**ADDENDUM NO. 2  
FOR  
CITY OF CUMMING  
LANIER BEACH SOUTH PUMP STATION, GRAVITY SEWER and FORCE MAIN**

**ADDENDUM DATE: July 8, 2011**

## Sewer Line Outfall Field Notes and Removal Requirements

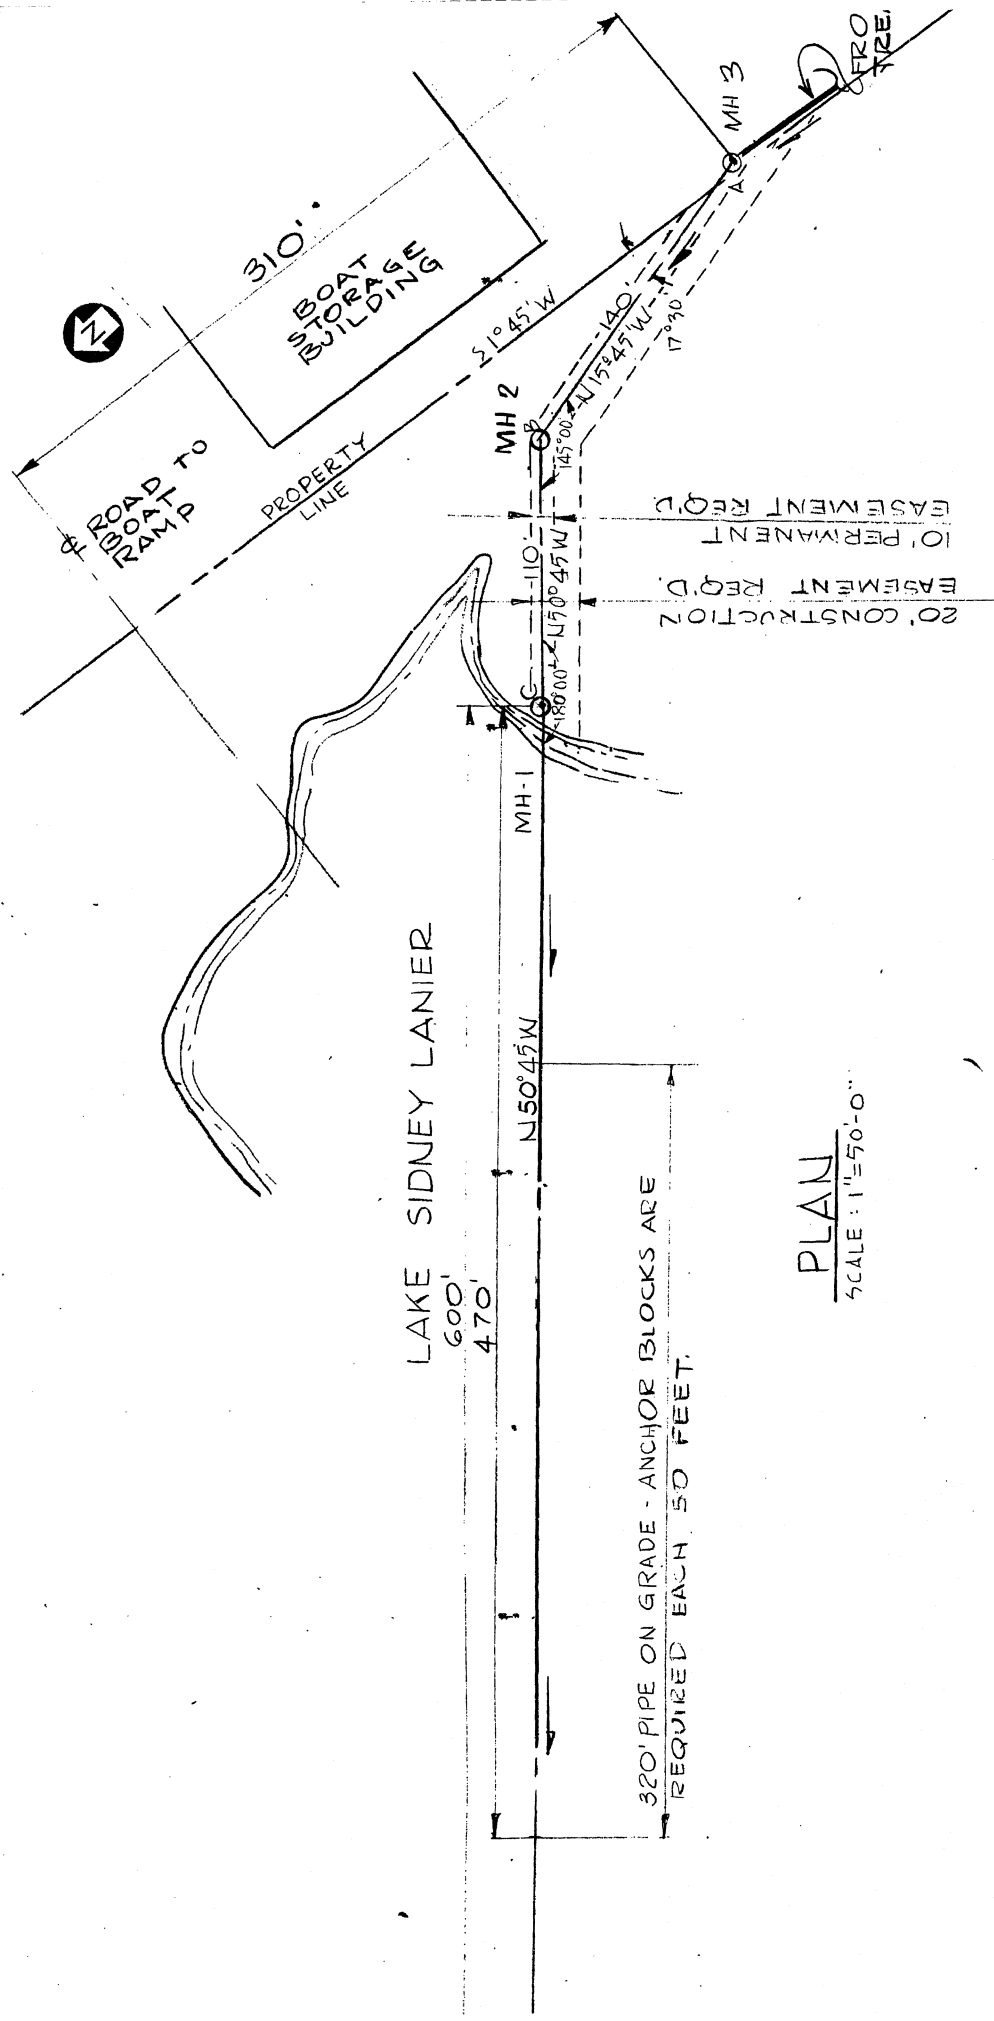
Man hole #1 is not on Corps property. Man hole #2 was not found, but per plans was supposed to be on Corps property. Man hole #3 was found at the shoreline edge with rip-rap placed around it.

The buried line between man hole 1 and 3 is 10" clay tile pipe.

The line from man hole 1 to the discharge is 10" cast iron. The cast iron pipe is laying visible on the lake bed the entire length down to the discharge. The pipe is supposed to be anchored with 6 or 7 concrete anchors measuring 20"T x 8"L x 26"W.

Removal requirements are as follows:

1. A 15' section of the clay tile pipe should be dug up and removed from the Corps property line extending 15' onto Corps property. The purpose of this is to remove any pipe that is crossing the Corps boundary line. Then, any pipe remaining buried will be either solely on private or solely on Corps property and there will not be any questions of if the city should keep an easement.

2. At the 15' point, the city should grout or cap the pipe so nothing can enter. Because the Corps property has not been maintained and is now forest, the pipe can remain buried from that point down to man hole #2. This will minimize impact to Corps property.

3. If there is a man hole #2 on Corps property, the precast concrete and metal man hole cover should be removed and dirt brought in to fill the hole back to existing grade. The pipe can remain buried from man hole #2 down to man hole #1.

4. At man hole #1, the precast concrete and metal cover should be removed. A 10' section of clay tile pipe extending back toward man hole #2 should also be removed. The end of the pipe remaining buried should be grouted or capped. Dirt should be brought in to fill any hole left at man hole #1 back to existing grade and rip-rap placed on top.

5. The entire length of cast iron pipe running into the lake from man hole #1 down to the discharge and any anchors should be removed.
6. The city will have to coordinate with dock permit holders of A1920 and A2029. These docks will need to be moved and any buried electric or water lines avoided if possible.
